## The Great Grid Upgrade Norwich to Tilbury

# Environmental Implications of Change – Thurrock 2

February 2025

AENC-ARC-CNS-REP-0026

#### Image 1: Proposed Change

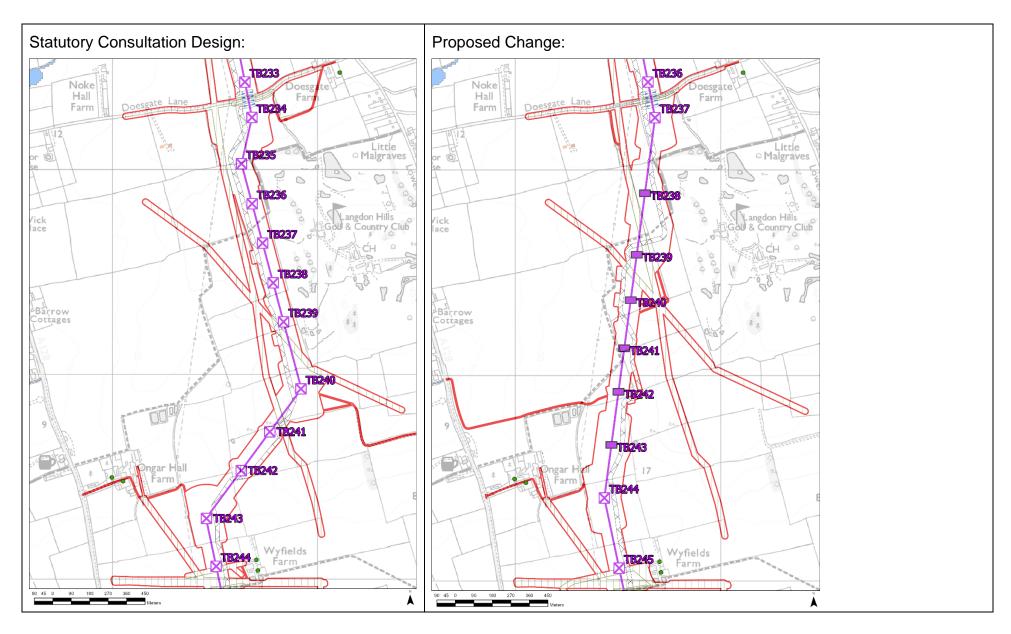
- 1.1.1 This Environmental Implications of Change document should be read alongside the associated Thurrock 2 targeted consultation leaflet.
- 1.1.2 Image 1 presents the Statutory Consultation design and the proposed change together with key environmental constraints using the key below.

Environmental Topic	Comments / observations / identified environmental implications of the proposed change when compared to the preliminary assessment presented in the PEIR
Agriculture and Soils	Indicative mapping shows similar 'Provisional Agricultural Land Classification' grading and soil types as identified for the design presented at statutory consultation. There would be no change to the type or significance of agriculture and soil effects as a result of the proposed change, when compared to the design and PEIR presented at statutory consultation
Air Quality	There would be no change to the type or significance of air quality effects as a result of the proposed change, when compared to the design and PEIR presented at statutory consultation
Ecology and Biodiversity	The proposed change would move the alignment within what appears to be more diverse grassland habitat to the east of Ongar Hall Farm when compared to the design presented at statutory consultation. Nevertheless, there would be no change to the type or significance of ecology and biodiversity effects as a result of the proposed change, when compared to the design and PEIR presented at statutory consultation.

Contaminated Land, Geology and Hydrogeology	There would be no change to the type or significance of contaminated land, geology and hydrogeology effects as a result of the proposed change, when compared to the design and PEIR presented at statutory consultation.

Environmental Topic	Comments / observations / identified environmental implications of the proposed change when compared to the preliminary assessment presented in the PEIR
Health and Wellbeing	The proposed change would result in more separation from the golf course, although the alignment does come slightly closer to isolated properties. Overall, there would be no change to the type of significance of health and wellbeing effects as a result of the proposed change, when compared to the design and PEIR presented at statutory consultation.
Historic Environment	The proposed change (including change to low height pylons) would locate the alignment closer to the scheduled monument Bulphan World War II bombing decoy, Doesgate Farm and two grade II listed buildings at Ongar Hall than the design presented at statutory consultation. The design presented at statutory consultation was located within the settings of these assets but beyond the existing 132 kV overhead line. The proposed change, although closer, would still be beyond the existing 132 kV overhead line and would follow its alignment therefore reducing the area of the landscape altered by overhead line infrastructure and not significantly changing the impact through change to setting from that reported in the PEIR. Overall, there would be no change to the type or significance of historic environment effects as a result of the proposed change, when compared to the design and PEIR presented at statutory consultation.

Hydrology, Land Drainage and Flood Risk	There would be no change to the type or significance of hydrology, land drainage and flood risk effects as a result of the proposed change, when compared to the design and PEIR presented at statutory consultation.
Landscape and Visual	The proposed change (including change to low height pylons) would move part of the alignment slightly to the west to follow a more direct route and would have a reduction in the number of pylons compared to the design presented at statutory consultation.
	The proposed change in alignment follows the lower slopes of a localised hill which rises to the east, towards the centre of the Langdon Hills Golf and Country Club. Whilst the proposed change would locate the alignment closer to residential receptors in the settlement at Bulphan, and at Ongar Hall Farm, it would retain some degree of separation. The proposed change would move the alignment further from recreational receptors at the golf club.

In terms of landscape, effects on landscape character are likely to be similar. This is because the design presented at statutory consultation and the proposed change would both introduce pylons into roughly the same part of the Sticking Hill Rolling Farmland / Wooded Hills landscape character area.
	Refer to visualisations in Annex A.
	Overall, there would be no change to the type or significance of landscape and visual effects as a result of the proposed change, when compared to the design and PEIR presented at statutory consultation.

Environmental Topic	Comments / observations / identified environmental implications of the proposed change when compared to the preliminary assessment presented in the PEIR
Noise and Vibration	There would be no change to the type or significance of noise and vibration effects as a result of the proposed change, when compared to the design and PEIR presented at statutory consultation.
Socio- economics, Recreation and Tourism	The proposed change would reduce the impact on the operations of Thurrock Airfield when compared to the design presented at statutory consultation. There would be no change to the type or significance of socio-economic, recreation and tourism effects as a result of the proposed change, when compared to the design and PEIR presented at statutory consultation.
Traffic and Transport	There would be no change to the type or significance of traffic and transport effects as a result of the proposed change, when compared to the design and PEIR presented at statutory consultation.

- 1.3.1 The proposed change would not materially change the conclusions that were reported within the PEIR (National Grid, 2024) which was published for statutory consultation. The PEIR can be viewed <u>here.</u>
- 1.3.2 If the proposed change is taken forwards, the baseline information (and environmental surveys) and assessment associated with this change would be provided in the Environmental Statement (ES).
